Access Compliance Report

Public Rights-of-Way

Intersection ID: 11628	Main Street: W_8TH_ST	Cross Street: N_PINE_ST	Location: W
ADA ID: BABCAC713B2F	Ramp Type: Perp	Initial Pass/Fail: Fail	Overall Compliance: No
		Severity Score: 12.5

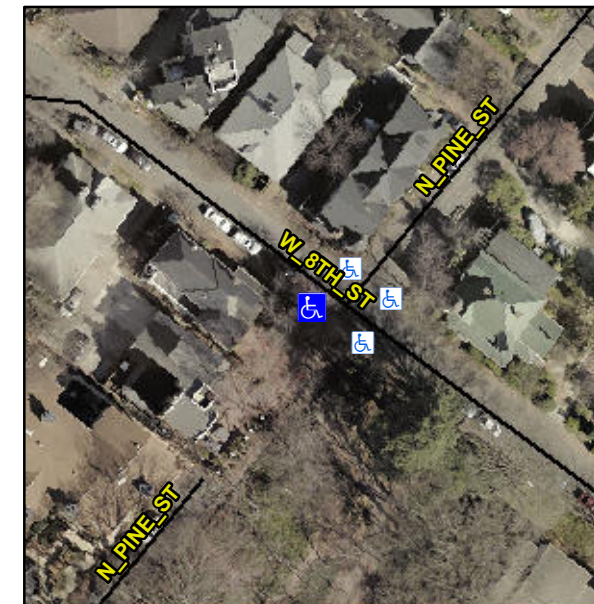
Surveyor Notes:

N/A

Not Found, R304.5.3

Possible Solutions:

Remove & Replace Entire Ramp.
